Access Compliance Report

Public Rights-of-Way

(Curb Ramps)

Intersection ID: 21135	Main Street: ALLISON_AV	Cross Street: SHARON_VIEW_RD	Location: NE
ADA ID: 3FBABF2FC1D8	Ramp Type: PerpDiag	Initial Pass/Fail: Fail	Overall Compliance: No
			Severity Score: 33.75

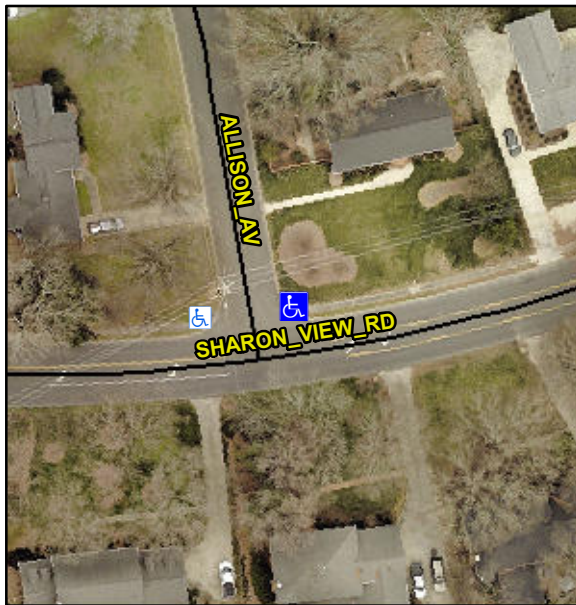
Not Found, R304.5.1, R304.5.3

Compliance	Description	Data	Compliance	Description	Data
N/A	Ramp Length (in)	77.0	Yes	Ramp Slope (%)	6.1
No	Ramp Width (in)	36.0	No	Ramp XSlope (%)	10.1
N/A	Flare Type LT	N/A	N/A	Flare Type RT	N/A
N/A	Flare Slope LT (%)	N/A	N/A	Flare Slope RT (%)	N/A
N/A	Flare Traversable LT?	N/A	N/A	Flare Traversable RT?	N/A
N/A	Landing Length (in)	N/A	N/A	DWS Provided?	N/A
N/A	Landing Width (in)	N/A	N/A	DWS Contrast?	N/A
N/A	Landing Slope (%)	N/A	N/A	DWS Length (in)	N/A
N/A	Landing X Slope (%)	N/A	N/A	DWS Full Width?	N/A
N/A	Landing Curb? (Y/N)	N/A	N/A	DWS Offset (in)	N/A
N/A	Shared Landing?	N/A			
N/A	Gutter Ponding?	N/A	N/A	Gutter Slope (%)	N/A
N/A	Gutter Lip Ht (in)	N/A	N/A	Gutter X Slope (%)	N/A
N/A	Painted X Walk1?	No	N/A	Painted X Walk2?	No
	X Walk 1 Direction	To W		X Walk 2 Direction	To S
N/A	X Walk 1 Width (in)	N/A	N/A	X Walk 2 Width (in)	N/A
	X Walk 1 Slope (%)	1.0		X Walk 2 Slope (%)	7.8
	X Walk 1 X Slope (%)	7.3		X Walk 2 X Slope (%)	1.6

Remove & Replace Curb Ramp With Two New Directional Ramps or Equivalent.
